City of Sumner **DESIGN COMMISSION**

AGENDA
Wednesday, February
21, 2024
6:30 p.m.

**a) 15403/15407 Main
Street**

DR-2023-0015 – Design Review for a
new commercial building to replace
one lost to a fire. Development
includes new 16,200sf building and
site improvements to .13 acre site.

Branks BBQ
Proposed Restaurant
South & West Elevation

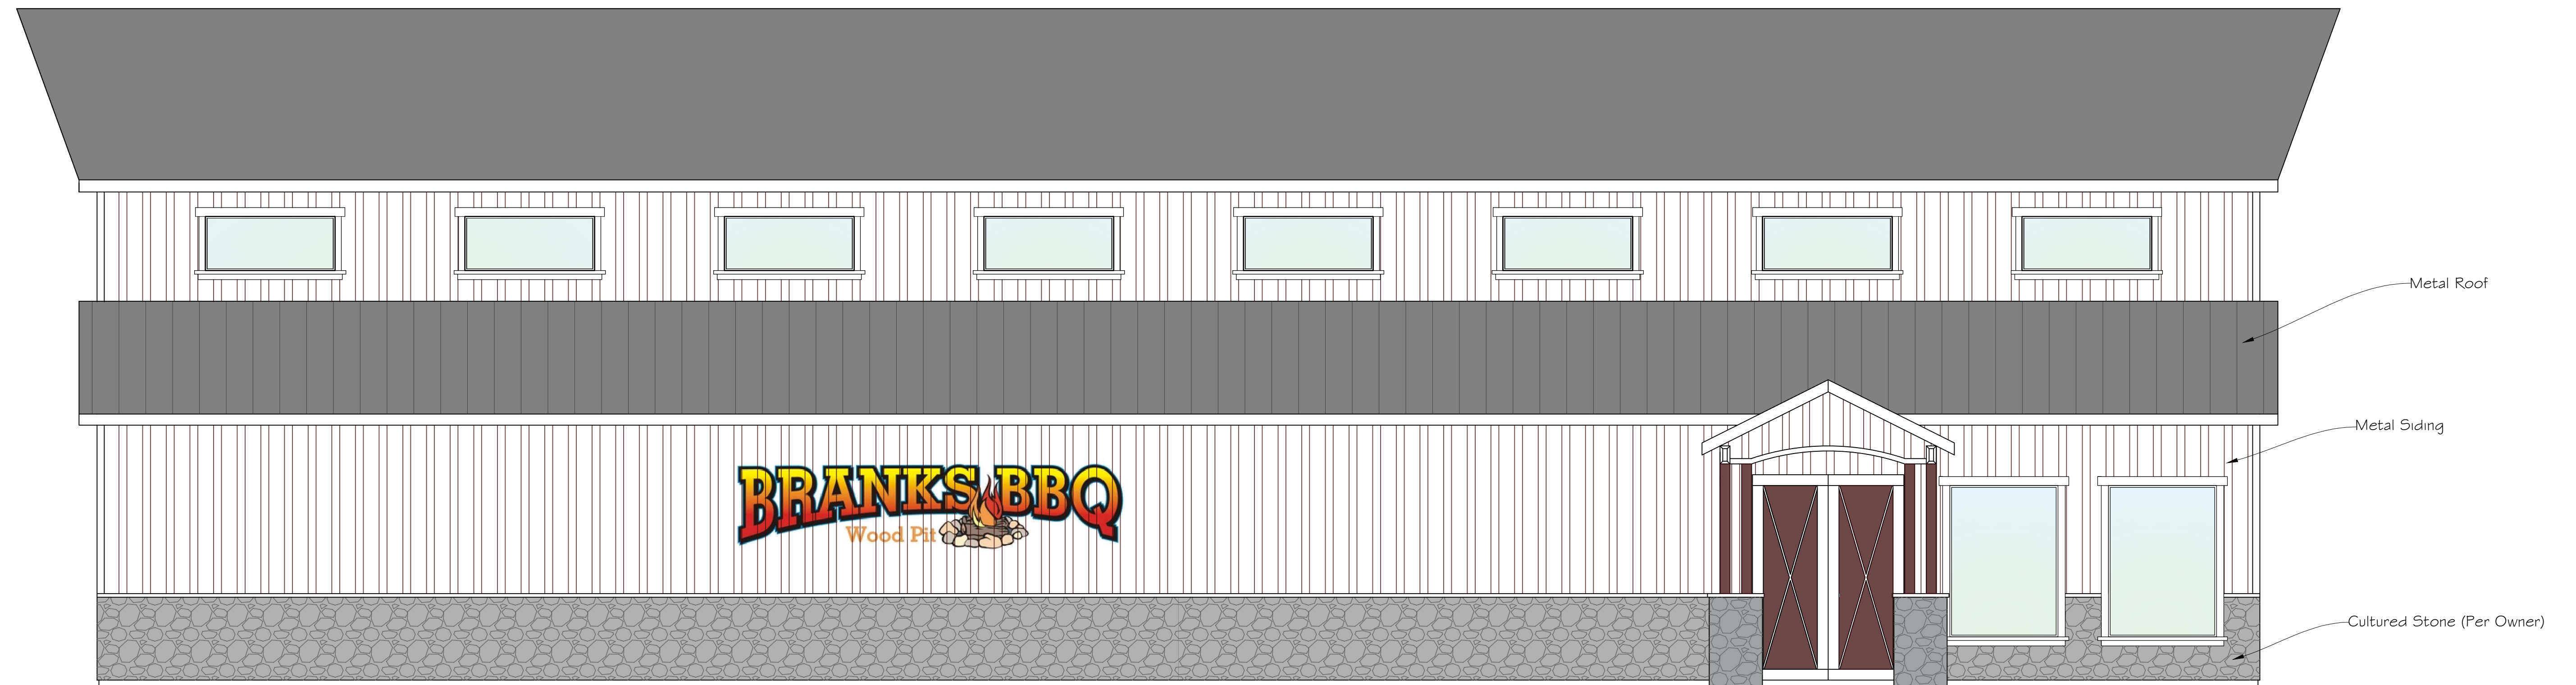
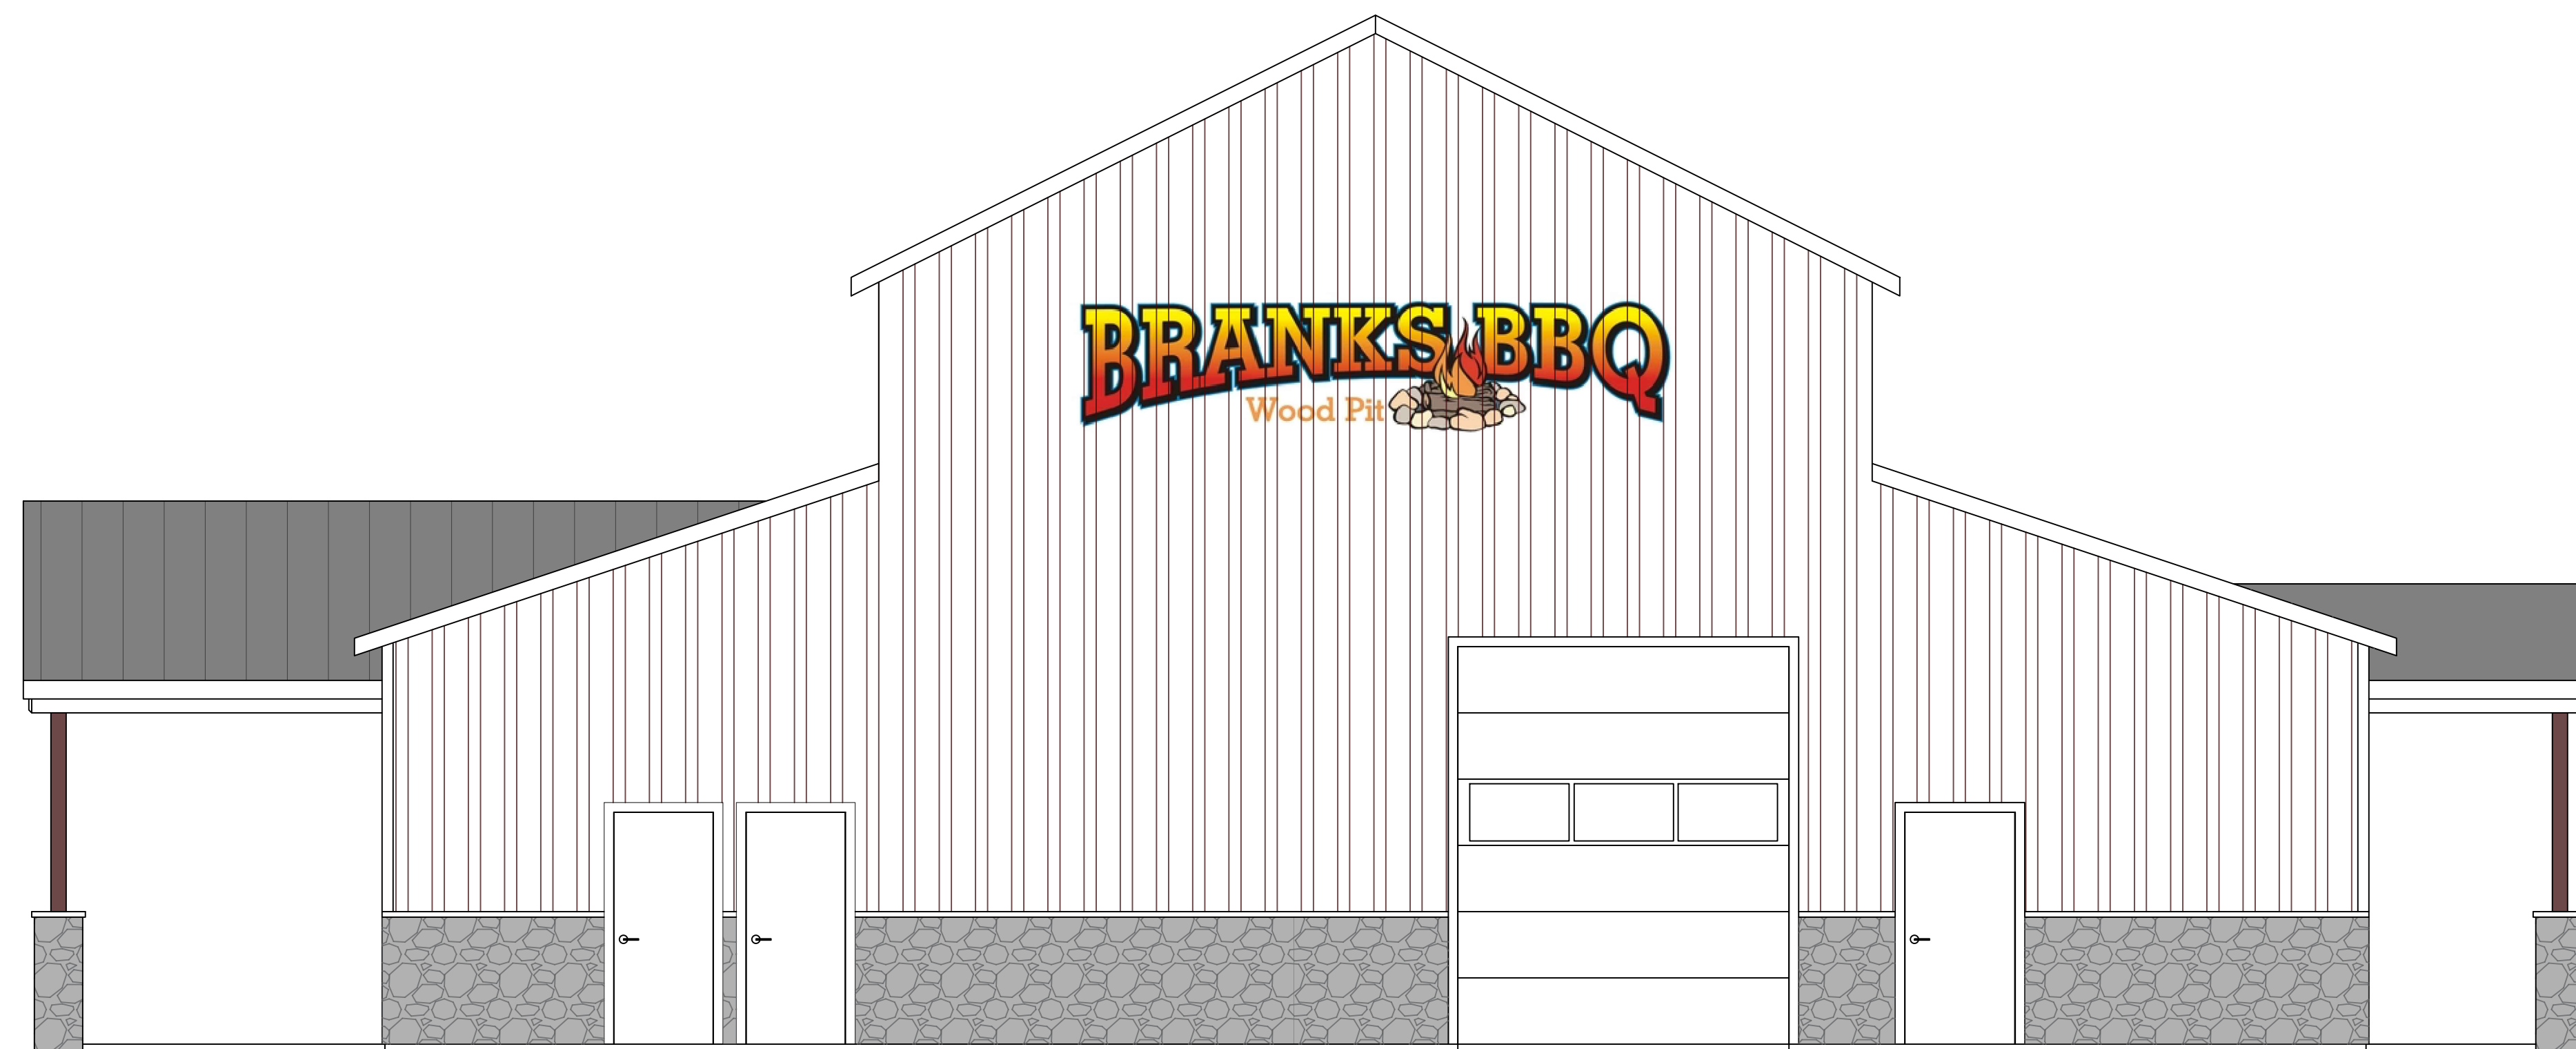
The proposed building includes a few areas that would meet the qualifications for blank walls, these include the east and west gable ends between the roof and windows and the first story segments adjacent to the entrance to the buildings end. The later of these two was discussed in a previous section of this report and includes the landscape strip called out in this section. The gable end sections on the east and west elevations could be looked at to see if anything could be added to break up the wall area. Ideas to consider could be horizontal banding to break up this wall, extended canopies or awnings, color change, windows and or a material change. Conditions look at this area and options.

5. **2.3.2 Design all visible facades and 2.3.10 Blank Walls.**
 - A. The gable end sections on the east and west elevations could be looked at to see if anything could be added to break up the wall area, ideas to consider could be horizontal banding to break up this wall, extended canopies/awnings, color change, windows and or a material change.

BRANK'S BARBEQUE
24XX 136TH AVENUE CT E, SUMNER WA
PRELIMINARY LANDSCAPE PLAN

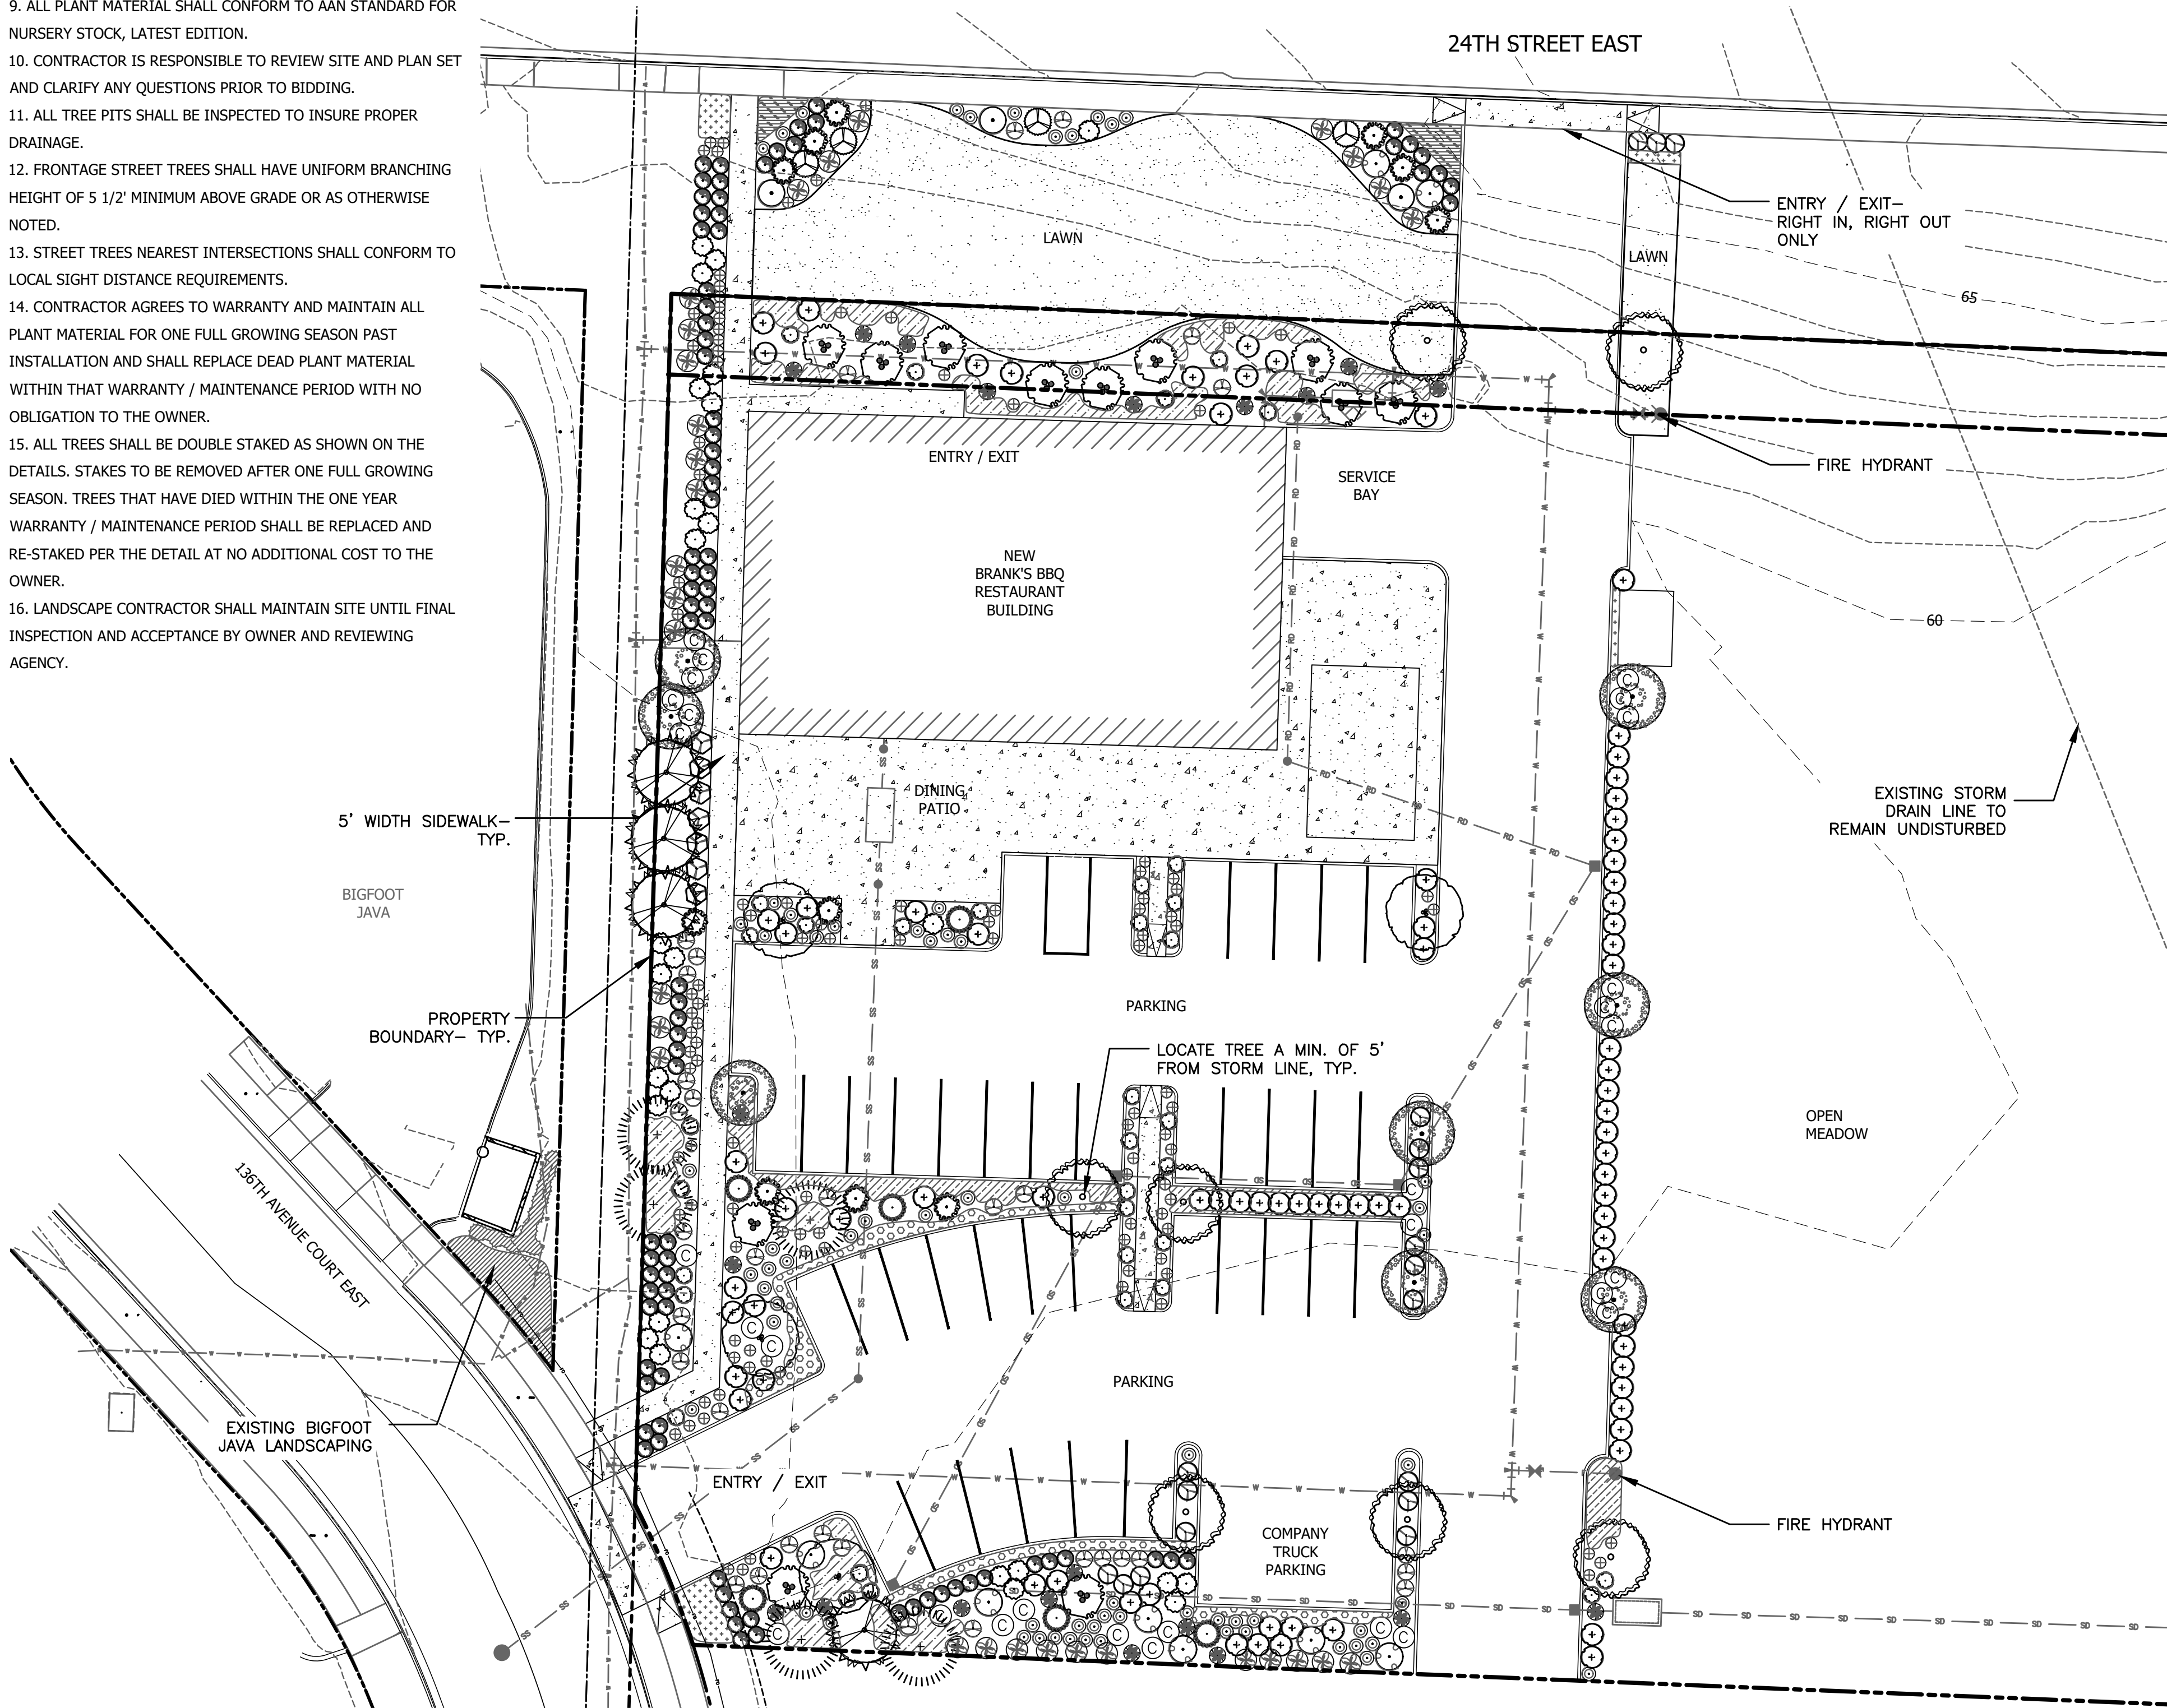
The proposed project is required to have 4,400 square feet of landscaping in order to meet the required 10% of the 44,000sf developed portion of the site. The project site plan labels 15,460 square feet; however, some of this may be counting offsite ROW landscaping. This still clearly has over 8,000sf of onsite landscaping and therefore exceeds the required amount of landscaping. This guideline is satisfied.
